Airport East Precinct

Addendum review of environmental factors

April 2016

Prepared by Aurecon Australasia Pty Ltd

FIGURE 2-2: Mill Pond Road

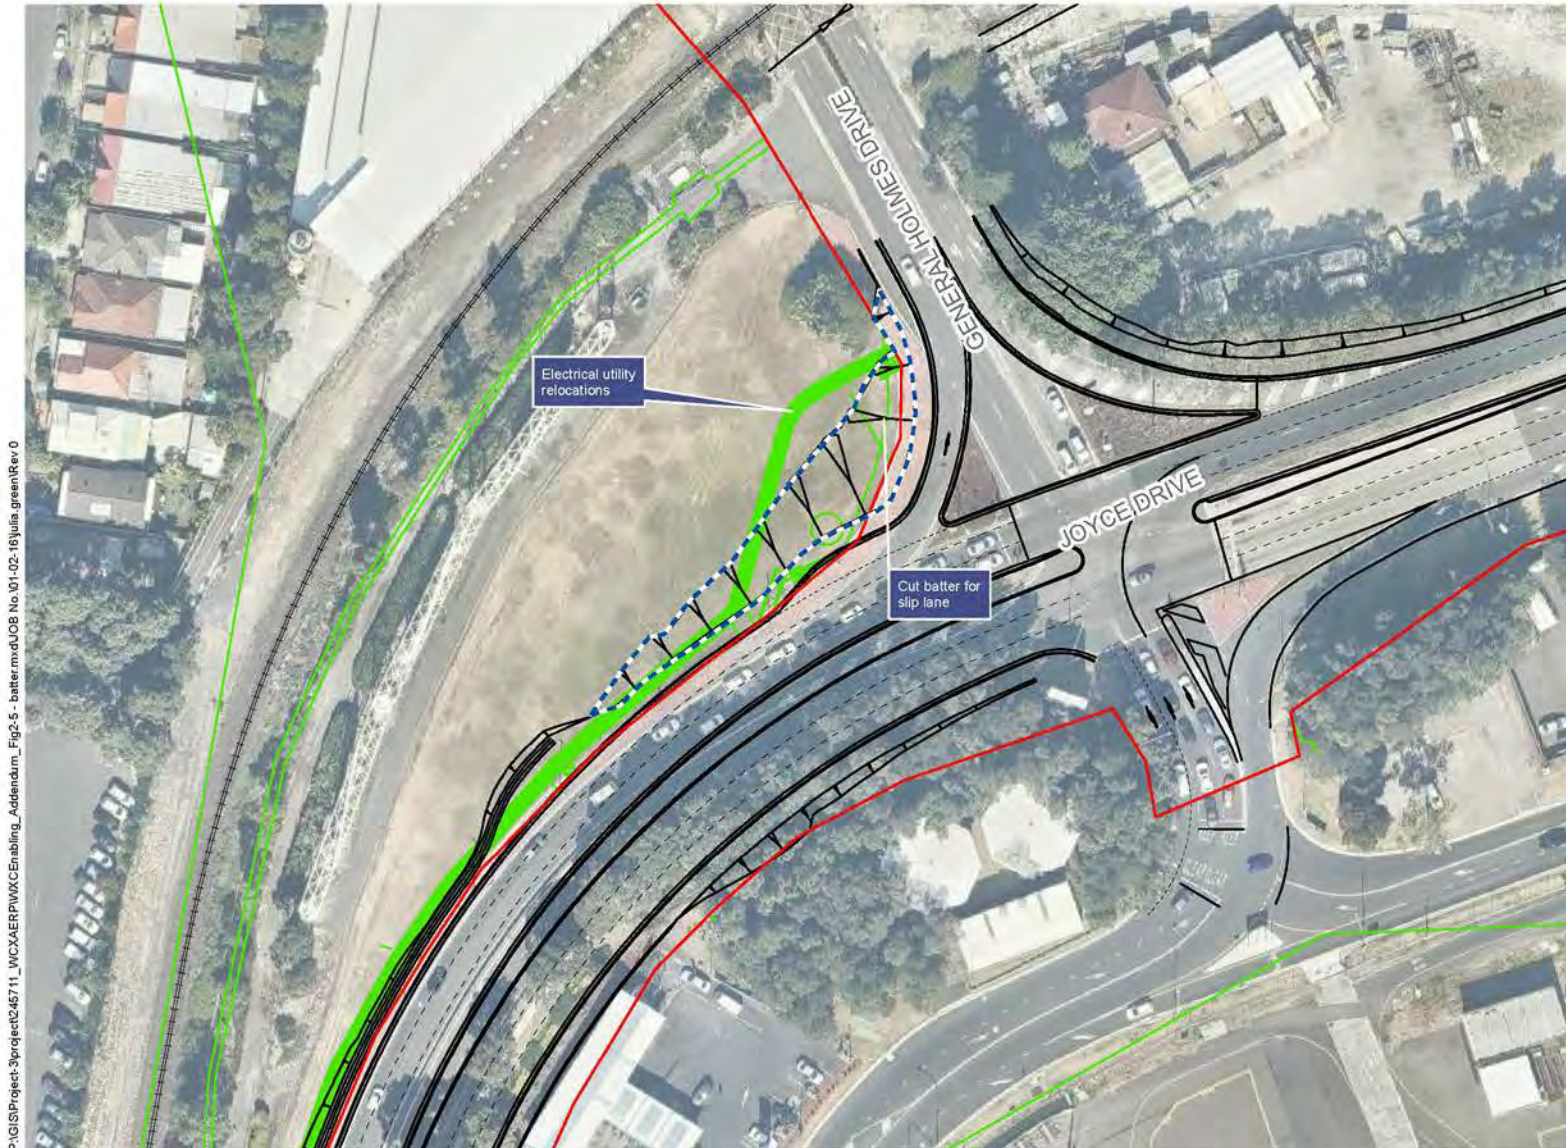
At the intersection of General Holmes Drive and Mill Pond Road, the revised proposal would involve changes to the lane layout to provide two right turn lanes from General Holmes Drive (northbound) onto Mill Pond Road (refer to Figure 2-2). This differs from the proposal, which only provided for one right-hand turn lane.

The revised proposal would retain the existing (i.e. current) two left turn lanes on Mill Pond Road to Botany Road. The raised concrete median that stopped traffic from General Holmes Drive turning left into Botany Road has been removed. This would allow access to Botany Road for oversized vehicles which cannot travel under the Wentworth Avenue underpass.
